Access Compliance Report Public Rights-of-Way (Curb Ramps)

Intersection ID: 10038086Main Street: SIKES_PLCross Street: N/ALocation:SEADA ID: DD69C9D1CB60Ramp Type: PerpInitial Pass/Fail: FailOverall Compliance: NoSeverity Score: 12.5

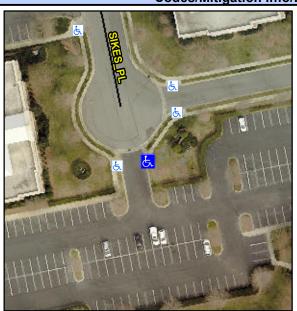
Field Measurements/Component Compilance							
Comp	liance Description	Data	Comp	liance Description	Data		
N/A	Ramp Length (in)	45.0	No	Ramp Slope (%)	8.7		
Yes	Ramp Width (in)	49.0	Yes	Ramp XSlope (%)	0.0		
N/A	Flare Type LT	N/A	N/A	Flare Type RT	N/A		
N/A	Flare Slope LT (%)	N/A	N/A	Flare Slope RT (%)	N/A		
N/A	Flare Traversable LT?	N/A	N/A	Flare Traversable RT?	N/A		
N/A	Landing Length (in)	N/A	N/A	DWS Provided?	N/A		
N/A	Landing Width (in)	N/A	N/A	DWS Contrast?	N/A		
N/A	Landing Slope (%)	N/A	N/A	DWS Length (in)	N/A		
N/A	Landing X Slope (%)	N/A	N/A	DWS Full Width?	N/A		
N/A	Landing Curb? (Y/N)	N/A	N/A	DWS Offset (in)	N/A		
N/A	Shared Landing?	N/A					
N/A	Gutter Ponding?	N/A	N/A	Gutter Slope (%)	N/A		
N/A	Gutter Lip Ht (in)	1.0	N/A	Gutter X Slope (%)	N/A		
N/A	Painted X Walk1?	No	N/A	Painted X Walk2?	N/A		
	X Walk 1 Direction	To W		X Walk 2 Direction	N/A		
N/A	X Walk 1 Width (in)	N/A	N/A	X Walk 2 Width (in)	N/A

Possible Solutions:					
Remove & Replace Entire Ramp.					
Surveyor Notes:					
N/A					
PROW/ADA:					
R304.2.2
